## FORMAL OBJECTION

SSD 80626208 — 8–10 New McLean Street, Edgecliff

*Demolition, Two-Lot Torrens Subdivision & 65-Apartment Residential Flat Building*

**Merrill Witt**

Figure 25: Extract from the Post-exhibition Report by DPHI for PP-2023-1648 with the proposed built form on the western portion of the site shown on the left

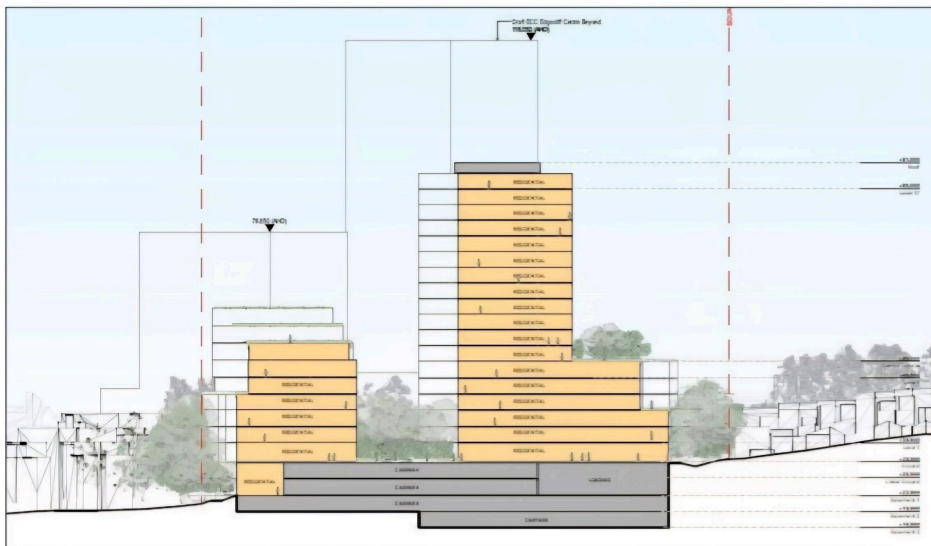
The building's common wall at Levels 1–4 is designed specifically for physical integration with a future eastern building. Without Stage 2, this wall is a permanent blank fire-rated facade — a built-form outcome that cannot be remedied by any condition of consent.

The Level 5 communal open space (355m<sup>2</sup>) is designed to link to the future eastern lot. Without the eastern building, it functions as an isolated rooftop terrace rather than the integrated communal amenity the design assumes.

The ground-level communal space is described in the Planning Ingenuity's Environmental Impact Statement (EIS) as an undercroft in the southern corner of the building. Its solar access and therefore likely usefulness to the residents is entirely unanalysed.

These are not minor inconveniences. They mean that a significant proportion of the amenity promised to future residents of the western building is contingent on a future development that has no legal obligation to proceed.

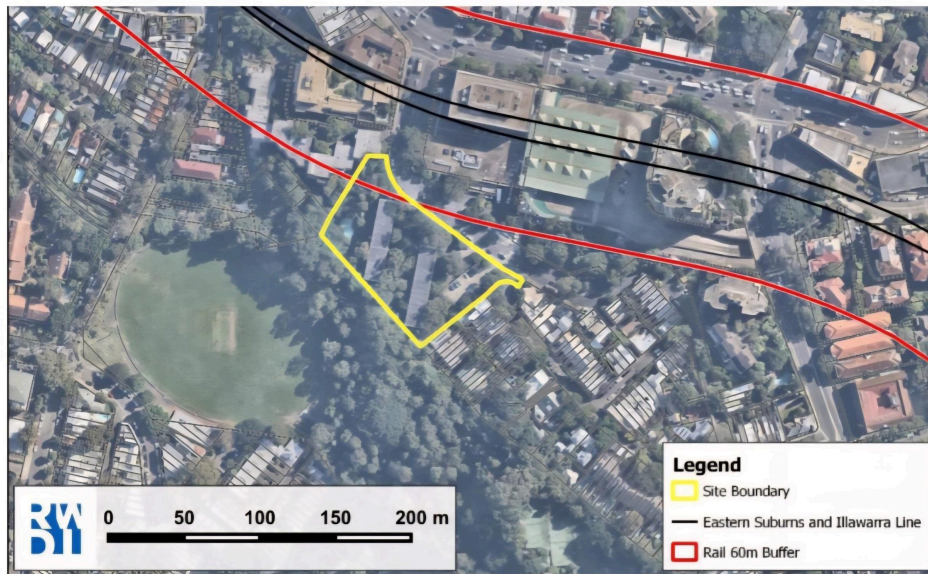
Table 2 of the Urban Arbor Arboricultural Impact Assessment indicates that 152 of 203 assessed trees are recommended for removal. This includes 8 trees classified as Category AA (high retention value) and 49 trees classified as Category A (moderate retention value). Approximately two-thirds of the highest-value trees on the site — and the majority of trees of moderate retention value — are proposed to be removed.

The scale of removal indicates that the building and basement footprint have not been designed to respond to the existing vegetation, which serves as a valuable biodiversity corridor to Trumper Park. No alternative design with a reduced footprint was tested or presented. The ADG design guidance under 3E specifically recommends that basement car parking be consolidated beneath the building footprint to maximise deep soil and retain significant trees. Instead, extensive excavation for the over provision of car parking spaces will lead to the destruction of most of the existing tree canopy and provide only limited opportunities for deep soil landscaping.
